CITY OF HORSESHOE BAY

PLANNING AND ZONING COMMISSION NOTICE OF REGULAR PUBLIC MEETING

Staff Review Comments

Recommendation to the City Council regarding the preliminary plat and final plat of Hidden Coves Planned Development (East side of Faultline Dr., across from Nichola Gay, north and south of Diagonal Dr, and north of Lost Echo)

PRELIMINARY AND FINAL SUBDIVISION PLAT HIDDEN COVES PLAT W36.3

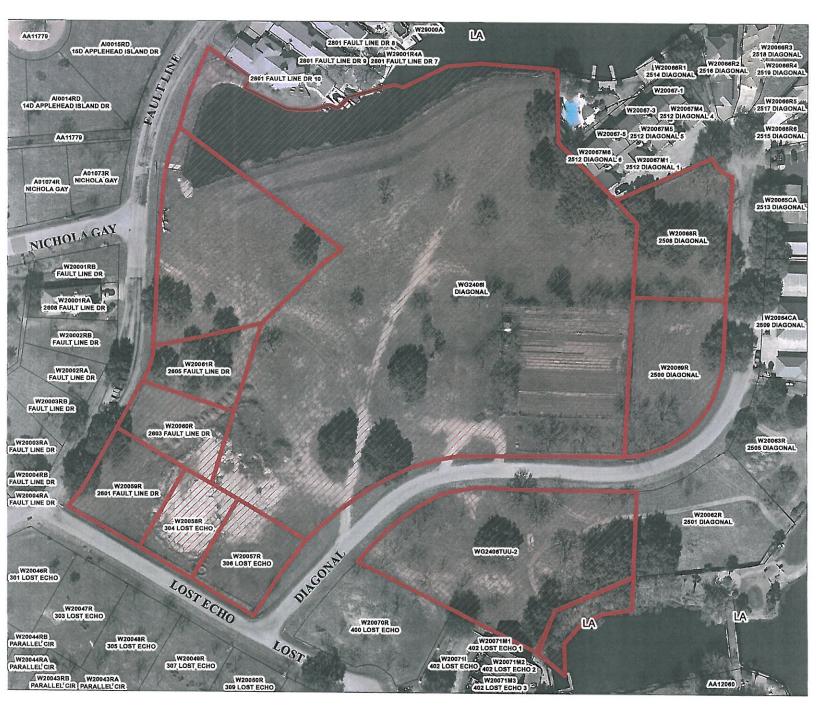
- 1. The title of the plat in every reference to it needs to be changed to: Horseshoe Bay West Plat No. W36.3 Hidden Coves Planned Development etc.
- 2. Add a complete list of all lots, tracts, and small portions of properties to be titled Current Zoning with each one's zoning classification (e.g., 85 Sq. Ft. Portion of Tract "LL-4" 2.029 Ac. LA Lake Area), and call the list now shown on the plat: Hidden Coves PD Zoning.

- 3. Show and better label/identify the extent of the 100 year floodplain on all Sheets.
- 4. Has Ensenada Lane been approved by Llano County 911? If so, is there a reason the ROW is shown as 60', when the ROW needs to only be 50'?

- 5. Add ROWs for all streets surrounding the subdivision.
- 6. C31 information is covered up by the Willis-Sherman stamp on the bottom of Sheet 9 of 10.

- 7. If Faultline Dr. is the front yard setback for Lot 20, then the south side of Ensenada Lane's setback as the side yard should be changed from 15' to 25', as corner lots in the R-4 Classification shall maintain a minimum setback of 25' from all side street lines. If Ensenada Lane is to be the front yard, its setback should be shown as 25'.

- 8. Show accurate reference ties to courses and distances of at least 2 recognized land corners on Sheet 2 of 10.
- 9. Finished floor elevations of 2 feet above the 100 year flood plain elevation shall be shown on the plat, for all waterfront lots and all lots in the 100 year floodplain.

- 10. Add a location and description of all monuments, which shall be placed at each corner of the boundary survey of the subdivision on Sheet 2 of 10.

- 11. Add: City of Horseshoe Bay between County and "FIRM" in the 4th line of the 3rd Note.
- 12. Correct the spelling of Lenght in all places on Sheet 9 of 10.
